In the Matter of a request under clause 21 of the
First Schedule to the Act for a
Change to the Queenstown Lakes
Proposed District Plan (Private Plan
Change 1)

By **THE HILLS RESORT LIMITED**

**Evidence of Richard Brett Thomson for The
Hills Resort Limited**

Dated: 13 March 2026

Site Plan – Overlay with Structure Plan (Revision Clouds)

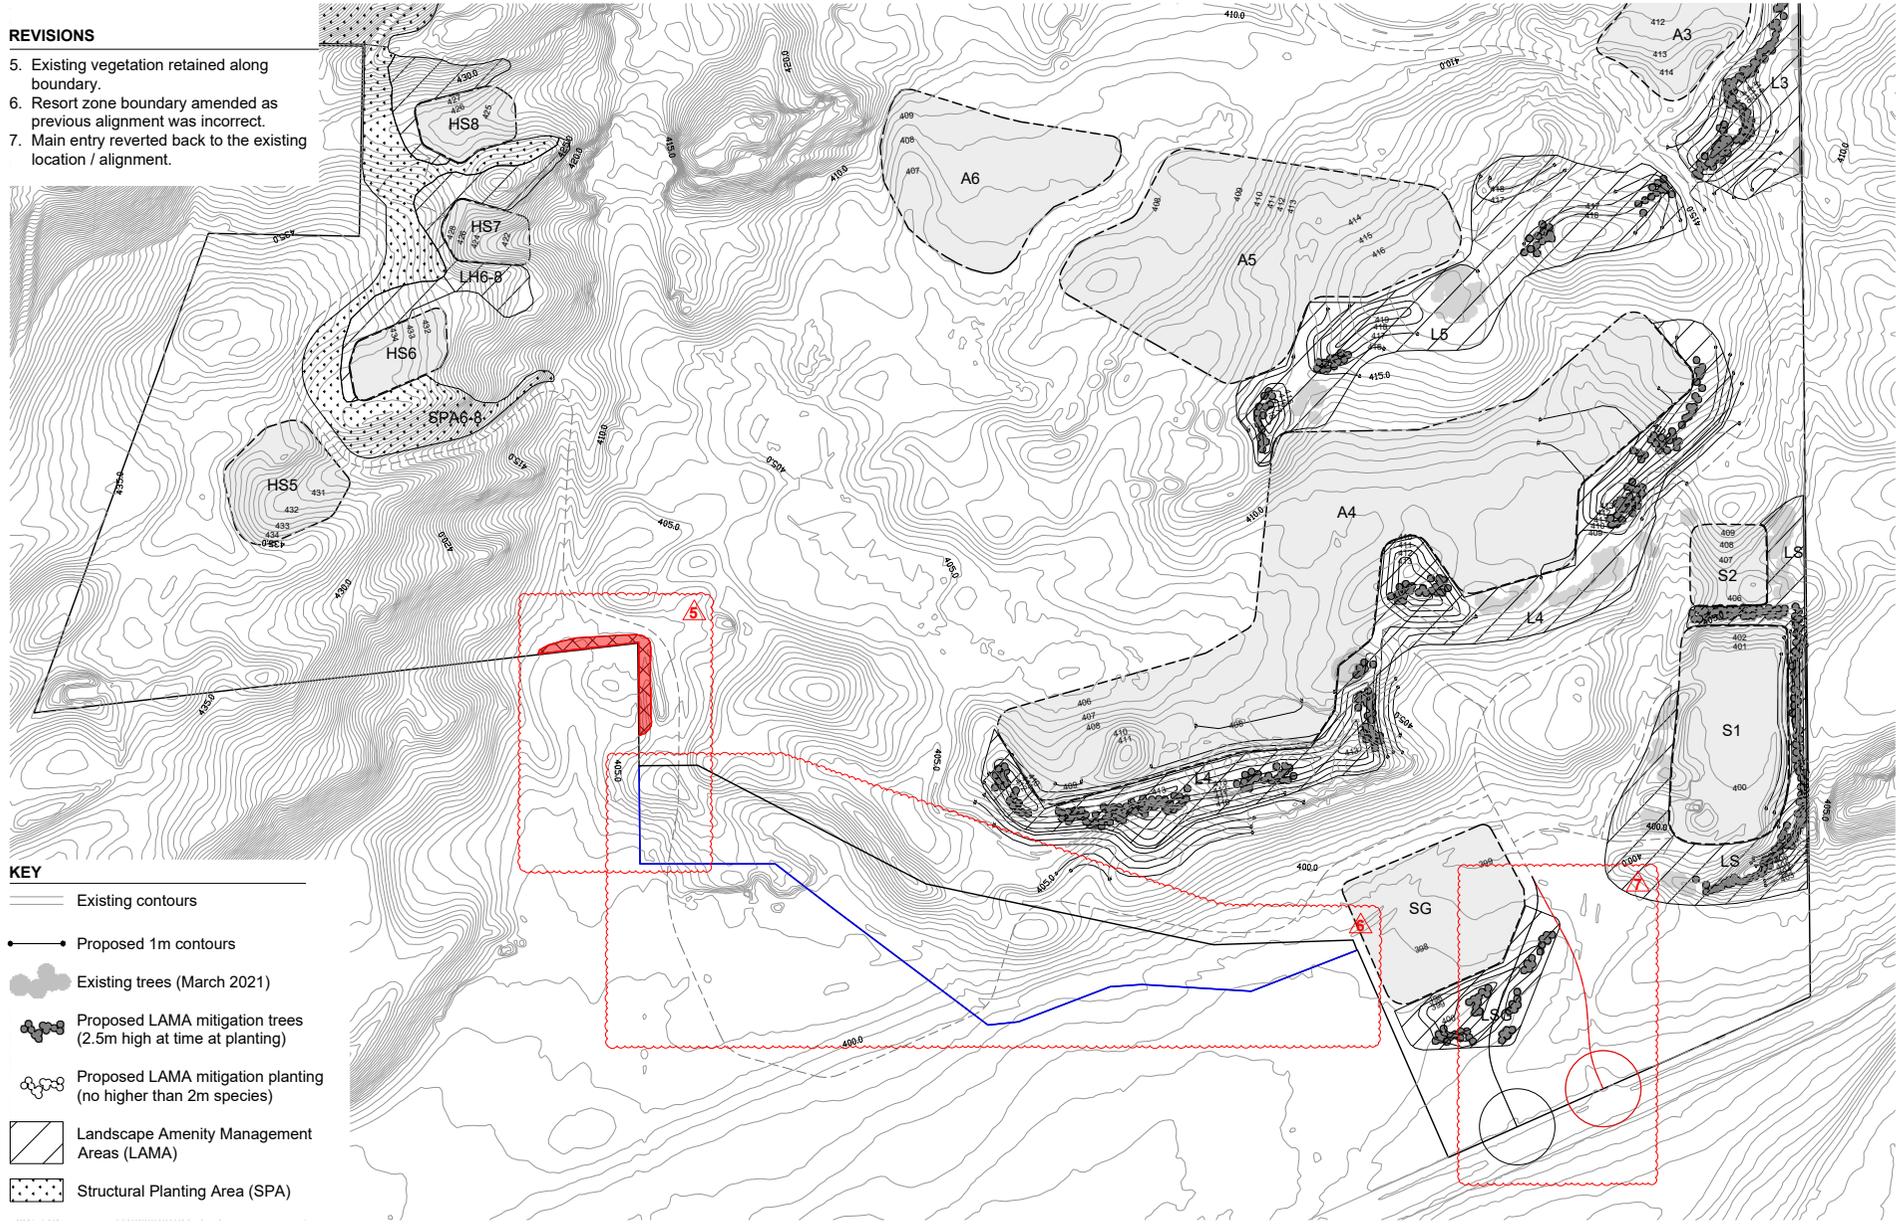
24. The revisions are as follows:
 - (a) **Revision 1:** The relocation of the Hogans Gully Road vehicle access to HS9-16 by 35 metres to the east, as recommended by Antoni Facey's evidence. This change does not alter the general routing of the access to the Homesites or impact the planting areas. I understand that Mr Carr's and Ms Pfluger's evidence covers this in more detail.

- (b) **Revision 2 :** The extension of the cycle/pedestrian trail adjacent to Hogan Gully Road in response to Submitter #16, Mark Williams for the Queenstown Trails Trust. Cyclist safety was also commented on by Submitter #17 the AW Brinsley Family Trust as well as Submitter # 20 Iris Webber and Dave Gibson. The cycle trail extension puts cyclists back on Hogans Gully Road, at the HS9-16 vehicle access, being a location to the east of the 64 Hogans Gully Road vehicle access to address a concern that I understand has been conveyed directly to THRL by Submitter #20 regarding the proximity of the trail to their home. I understand that Mr Carr covers this change in more detail in his evidence.

- (c) **Revision 3** : The expansion of the Structural Planting Areas (**SPA**) in three areas, as per the recommendation in Bridget Gilbert's evidence.

- (d) **Revision 4** : The repositioning of HS15, to the north as per recommendations in Bridget Gilbert's evidence. It is also proposed to lower the maximum building height for this Homesite by two meters, from 6.5 metres to 4.5 metres, to minimise visual impacts of future built form.

- (e) **Revision 5** : The minor repositioning of the cycle/pedestrian trail where it traverses the eastern part of the Zone, near 214 McDonnell Road, along with the identification of existing boundary planting that is to be retained in this location, to address matters raised by Submitter #15, Simon Dan, in relation to amenity and privacy.

- (f) **Revision 6** : Correction of the location of the HRZ zone boundary, which was inadvertently incorrectly shown on the notified Structure Plan. (This change is shown in blue).

- (g) **Revision 7** : The main entrance to the Resort on McDonnell has been repositioned back to its original (status quo) location, as the repositioning shown in the notified Plan Change Request documents is no longer necessary. The repositioning was to accommodate a planned water storage reservoir, which is no longer required.

- (h) **Revision 8**: The extension of Structural Planting Area 9-12 to the west, to integrate development within this part of the Zone with future development on the adjacent BHT land.

- (i) **Revision 9**: Extension of the HS16 LAMA to join with existing landform to the east, and the addition of specimen trees (see detailed LAMA Sheet 03).

- The changes made since notification are shown in red
 - The corrected zone boundary is shown in blue
1. Hogans Gully Road access point for Homesites shifted to align with the recommended location.
 2. Additional trail aligned parallel to Hogans Gully Road shown.
 3. SPA extended to infill 'opening' as recommended.
 4. HS15 Homesite shifted as recommended.
 5. Trail alignment shifted away from the neighboring boundary. Existing vegetation retained along boundary.
 6. Resort zone boundary amended as previous align was incorrect.
 7. Main entry reverted back to the existing location / alignment.
 8. SPA extended to integrate future BHT land development.
 9. LAMA extent and contour amended to tie in to adjacent escarpment (refer to detail sheet).

5. Existing vegetation retained along boundary.
6. Resort zone boundary amended as previous alignment was incorrect.
7. Main entry reverted back to the existing location / alignment.
